Motorola Mobility LLC.

Product Equality Declaration

The differences between AP and previous as below:

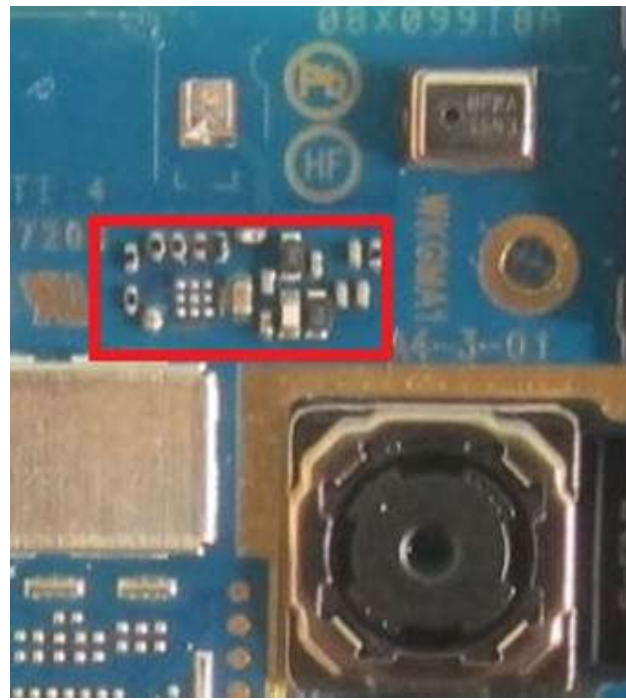
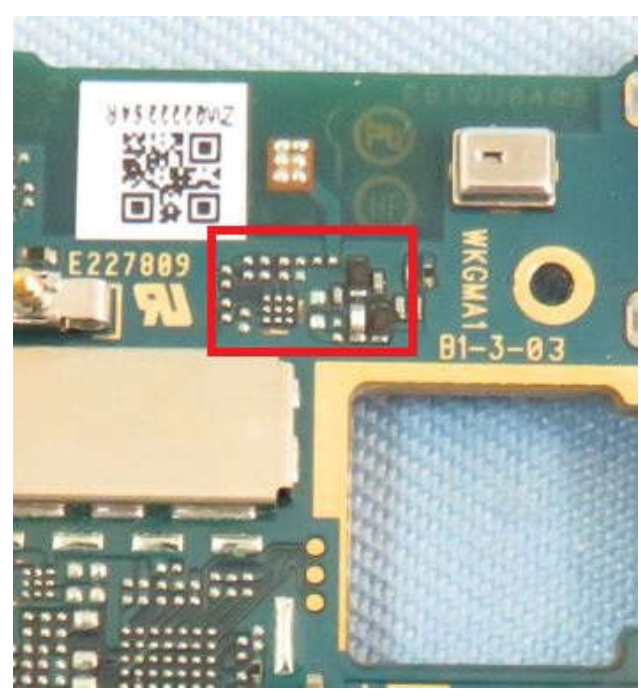
Previous 711913-02

Current 742708-02

Previous: Manual to remove SAR Sensor Chip and SAR Sensor shrapnel;

Current: Optimizing the BOM patch and removing the Sar sensor and its matching circuits.
